From: Barkley, Erik J (317H) [erik.j.barkley@jpl.nasa.gov]
Sent: Wednesday, April 14, 2010 5:31 PM
To: Scott, Keith L.
Subject: RE: RIDs on CCSDS Green Book

Thank you for reviewing the SIS-DTN Green Book. I have a question about your item (a) and a bunch of proposed resolutions for your approval conditions that I'd like to talk with you about. Can you either call me at 703.983.6547 or propose some times when you'd be available to chat?

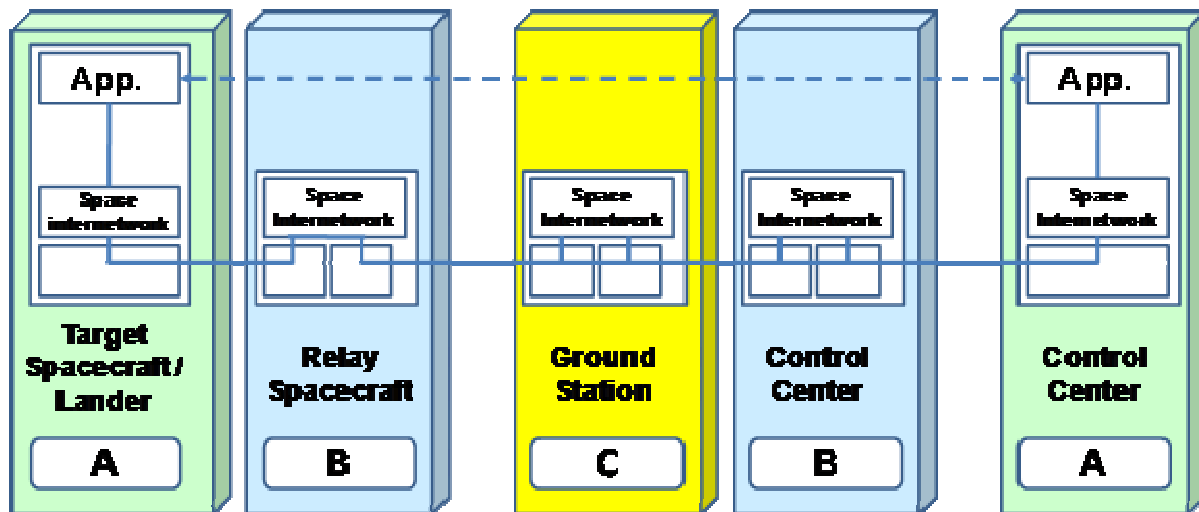
b) more of a question: does very long propagation delay need to be noted as an issue in scenario 3.2 ? Short contact duration is cited...why not the inverse (long contact duration but with long propagation delay)?

Good catch. I added the text:

- The one-way light time (and hence the round-trip light time) between the ground station and the spacecraft may be large.

As an issue there.
